SERVICE DIRECTIVE BULLETIN NO. 0099

1. SUBJECT: Non-Conforming Tie Rod Assemblies, P/N 28-16498-9 & 28-16498-101
2. MODEL: F-28F, 280F, and 280FX

Figure 1. Tie Rods, P/N 28-16498-9 & 28-16498-101

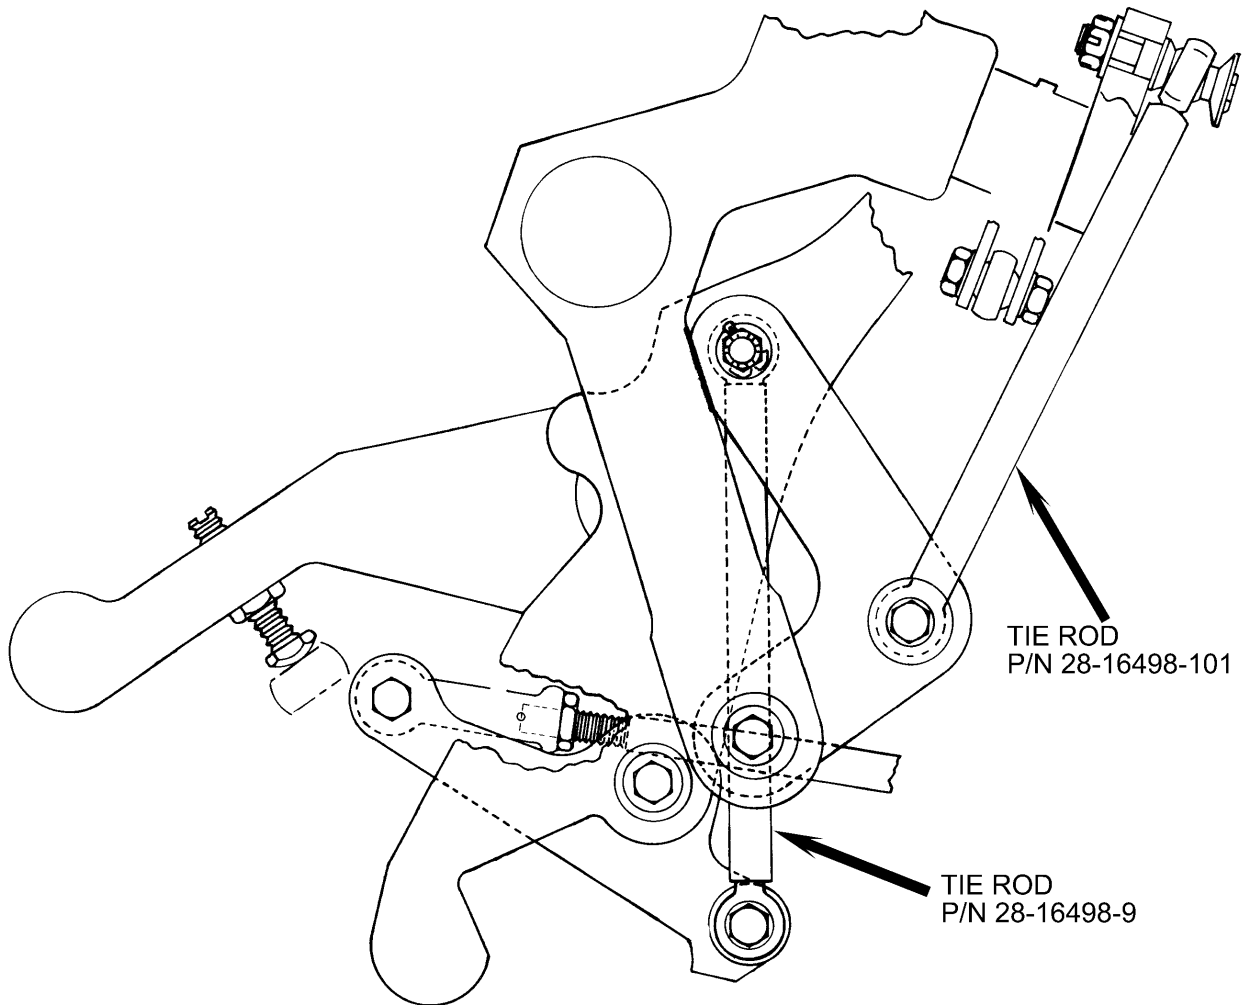
- B. Remove the tie rod, P/N 28-16498-9 and /or 28-16498-101, from the throttle correlator assembly (Refer to Figure 1).
- C. Determine if the tie rods conform to the approved drawings using the following procedures:

1. Using a gram scale, weigh the tie rod, P/N 28-16498-9.
 - a. If the tie rod weighs approximately 30.5 grams, the tie rod does not conform to the approved drawings and must be removed from service and/or parts inventory.

- b. If the tie rod weighs approximately 36.5 grams, the tie rod conforms to the approved drawing and may be returned to service and/or parts inventory.

2. Using a gram scale, weigh the tie rod, P/N 28-16498-101.
 - a. If the tie rod weighs approximately 31.0 grams, the tie rod does not conform to the approved drawings and must be removed from service and/or parts inventory.
